COUNCIL ASSESSMENT REPORT

Panel Reference	2017HCC010
DA Number	DA/675/2017
LGA	Lake Macquarie City Council
Proposed Development	Mixed Use Development (Residential Flat Building, Commercial Premises and Associated Works)
Street Address	482 The Esplanade, WARNERS BAY (Lot 122 DP 578045, Lots 1 & 2 DP 1116535) 486 The Esplanade, WARNERS BAY (Lot 3 DP 32518) 488 The Esplanade, WARNERS BAY (Lot 4 DP 32518) 12 King Street, WARNERS BAY (Lot 2 DP 155951) 14 King Street, WARNERS BAY (Lot 1 DP 155951) 16 King Street, WARNERS BAY Lot 122 DP 578045, 1 Howard Street, WARNERS BAY (Lot 3 DP 155951)
Applicant	YPI Yahav Property Investments (Warners Bay) Pty Ltd
Owner	YPI Yahav Property Investments (Warners Bay) Pty Ltd
Date of lodgement	3 January 2017
Number of Submissions	20 Submissions from 14 Authors
Recommendation	Approval
Regional Development Criteria (Schedule 4A of the EP&A Act)	The development has a CIV of \$44 million therefore being above the \$20 million threshold for Regional Development (at time of lodgement).

Executive Summary for Supplementary Report

Figure 1: Setbacks at the southern boundary for The Esplanade tower

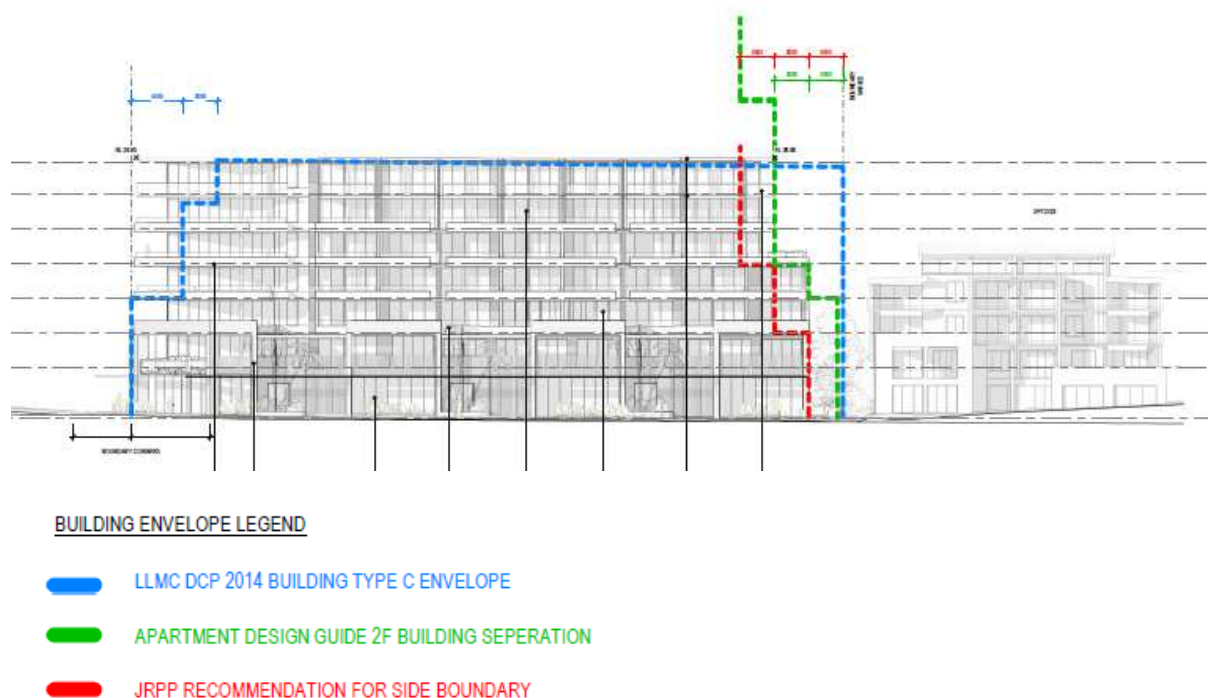
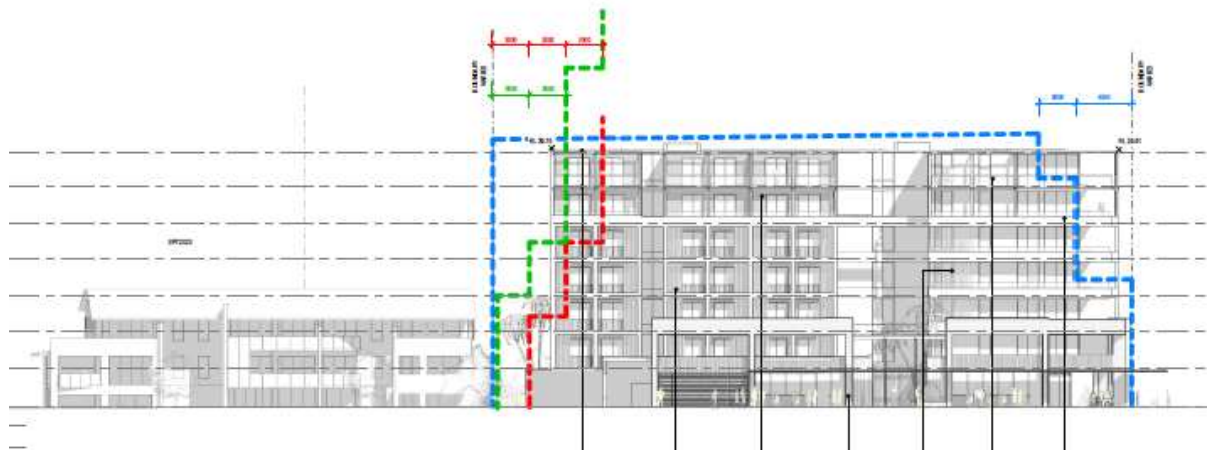
In response the applicant provided amended plans that increase the setback of the ground level of The Esplanade building at the southern boundary to 3 metres for levels 1 to 4. Level 5 provides 3 metre setback to the balcony, and a 7 metre setback to the building wall, whilst levels 6 and 7 provide a 6 metre setback to the balcony and similarly a 7 metre setback to the building wall. These setbacks are shown visually below in Figure 1, whereby the building setbacks for the DCP, ADG and JRPP are compared.

Figure 3: Permitted building envelope

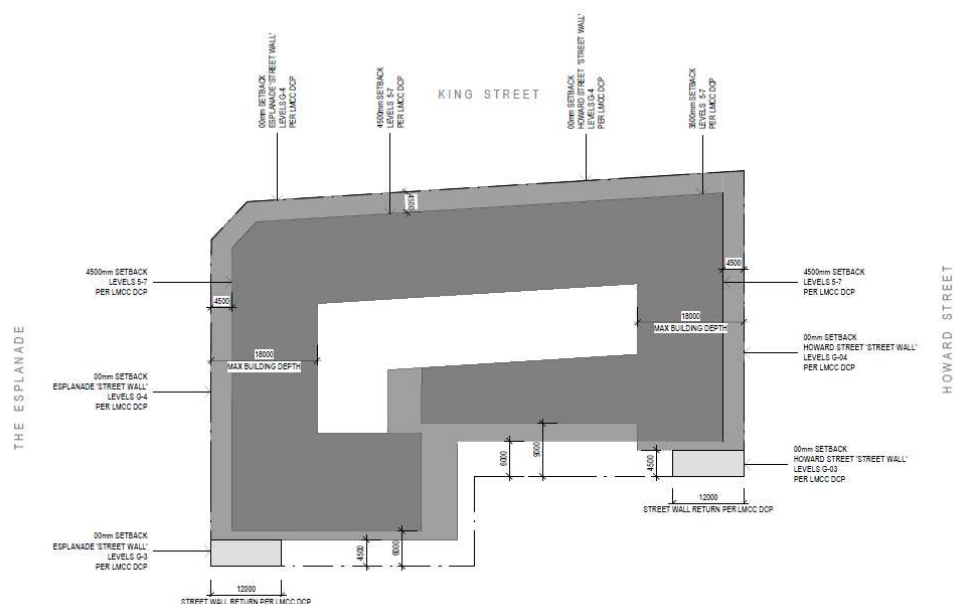
The permitted form by the ADG and DCP is compared to the amended form relative to the JRPP nominated setbacks (refer to Figure 3 below). This analysis identifies that a greater building form could be accommodated by the development site, which would have significantly different outcomes for the streetscape of King Street and the amenity for the existing development at 492 The Esplanade.

Figure 4: Overlooking analysis for The Esplanade

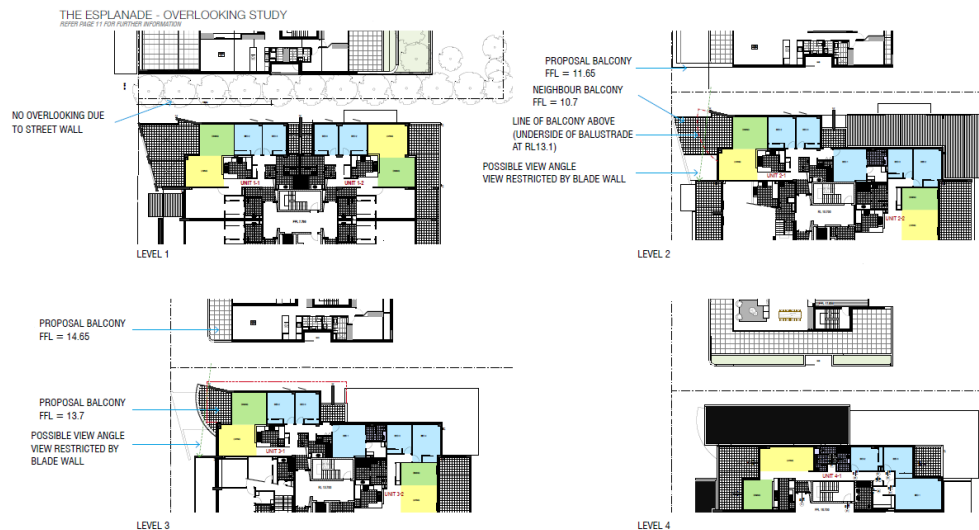
The overlooking study analyses the building setbacks/separation of the proposed development at 482 The Esplanade and the existing development at 492 The Esplanade, the floor levels of the relevant storeys of each building and the use of the internal rooms of 492 The Esplanade.

At level 1 the separation will be 5-6 metres, with the solid wall of the proposed development limiting any overlooking. At levels 2 and 3 a floor level difference of approximately 1 metre combined with a blade wall at 492 The Esplanade restricts overlooking to the forward half of the existing balcony. At level 4 a similar floor level difference exists, with a building separation of approximately 10 metres from the balcony and 14 metres from the building wall to the existing level 4 unit and balcony at 492 The Esplanade. Refer to Figure 4 below:

Figure 5: Overlooking analysis for Howard Street

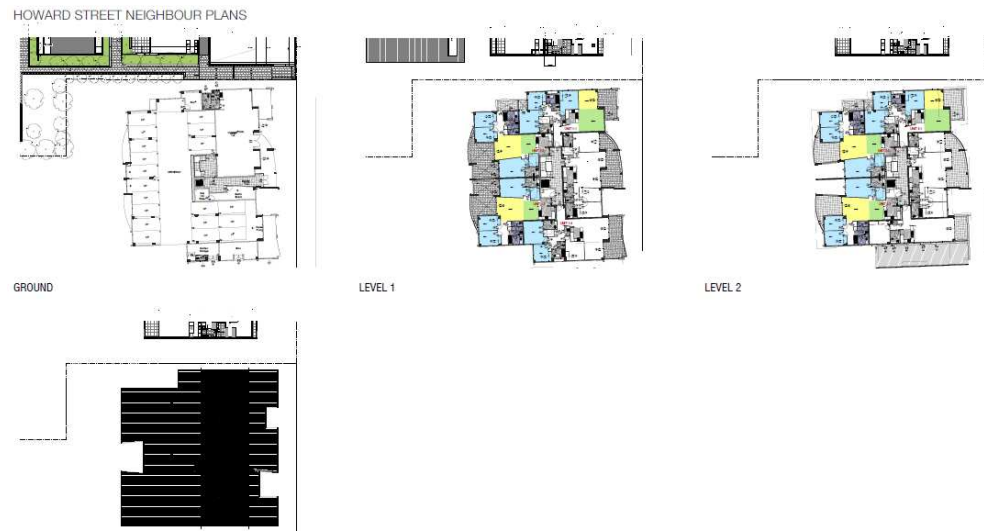
With regard to the Howard Street tower, limited privacy concerns exists due to the orientation, separation distance and level changes between the development, and screening of balconies for the existing residential units fronting Howard Street . Refer to Figure 5 below:

Figure 9: Details of encroachments *

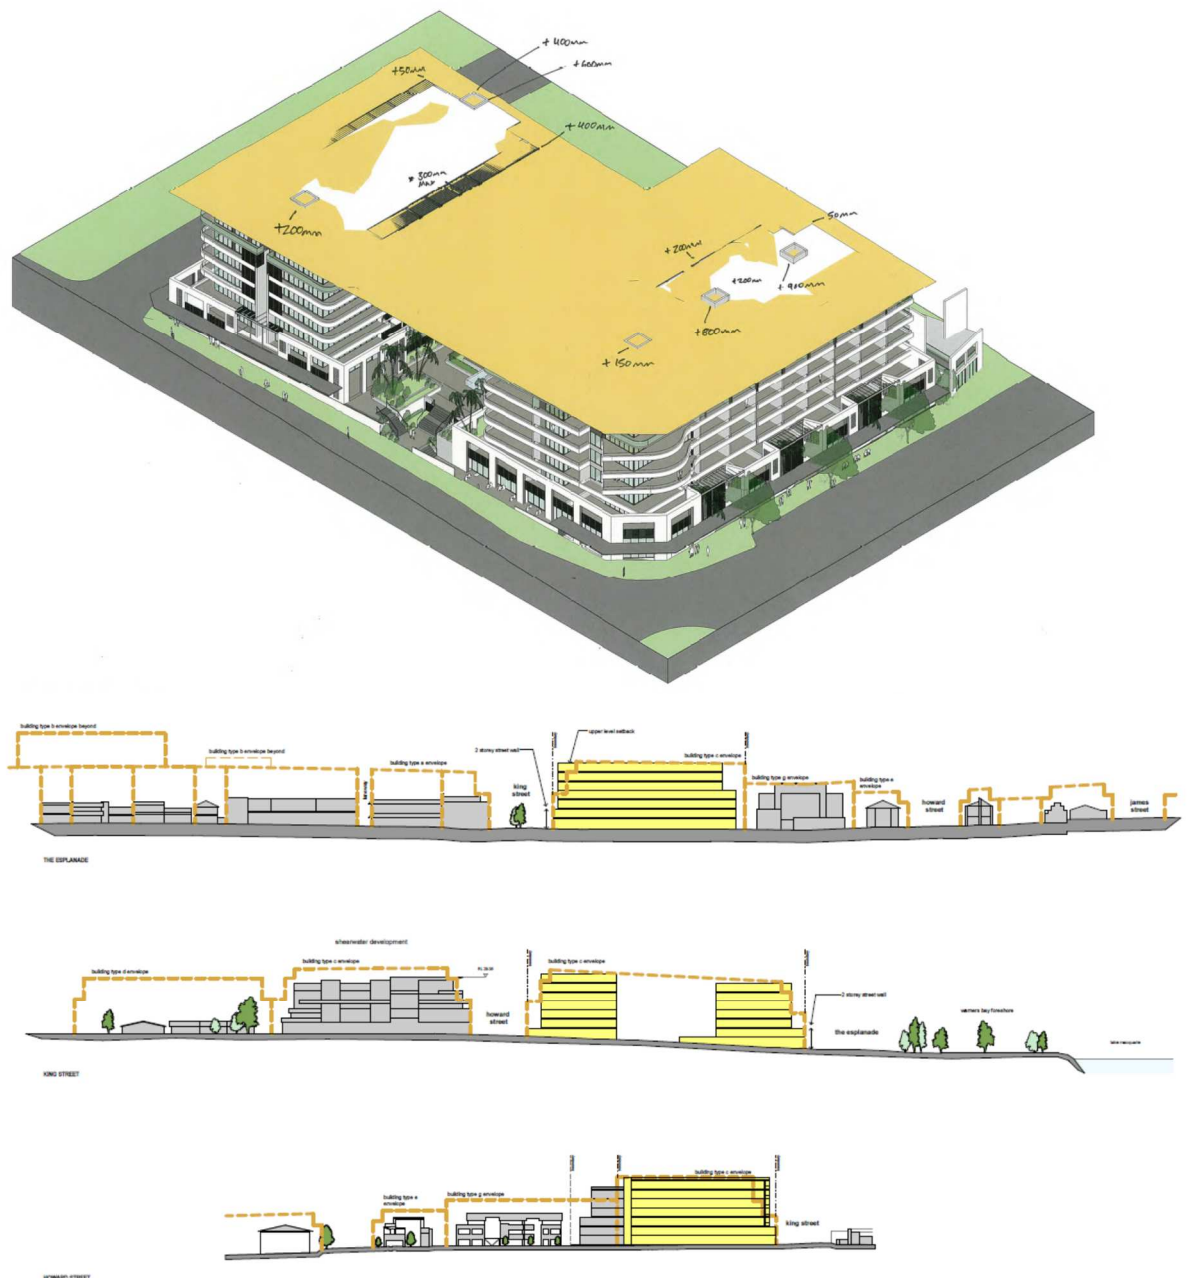
- The lift over run on The Esplanade tower up to 900mm. Other lift overruns on both towers exceeding the height (by 800mm, 600mm, 200mm and 100mm).
- The roof structure for the Howard Street tower up to a maximum of 300mm over approximately one third of the roof area.
- The roof structure for The Esplanade tower up to a maximum of 200mm over approximately 10% of the roof area.

These exceedances are centrally located within the roof areas of both towers and equate to a variation to the 22m maximum height of building by 0.9m or 4.1%. For the Howard Street tower the area of the roof (987m²) which exceeds the height limit is approximately 30% or 296m², whilst for The Esplanade tower the area of roof (1240m²) which exceeds the height limit is approximately 10% or 124m². Note the total site area is 5,093.9m².

Figure 10: Cross section of encroachments *

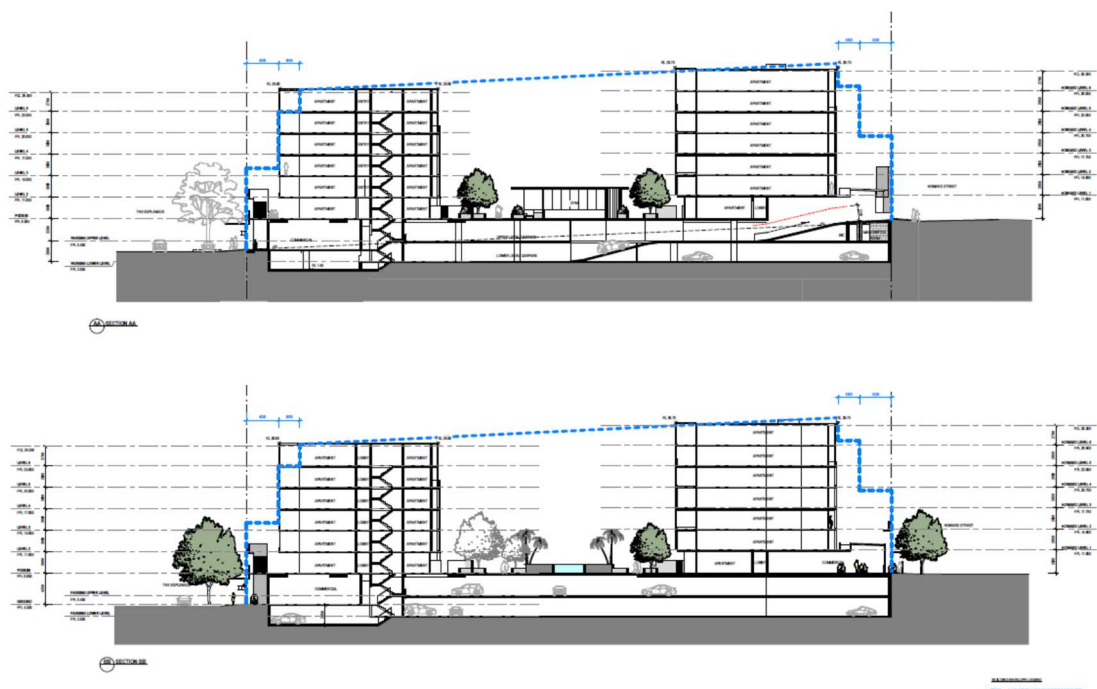
Additionally the 4m fall across the site (east to west) constrains the ability to maximise the built outcome in terms of the building envelope without exceeding the height limit, see Figure 10. Even with the narrow building alignment perpendicular to the slope, minor height exceedences have occurred. Note, the development has compliant floor to ceiling heights and slab thickness with the exception of the Tenancies 5, 6 & 7 which have a varying internal height of 2.7 to 3.6m.
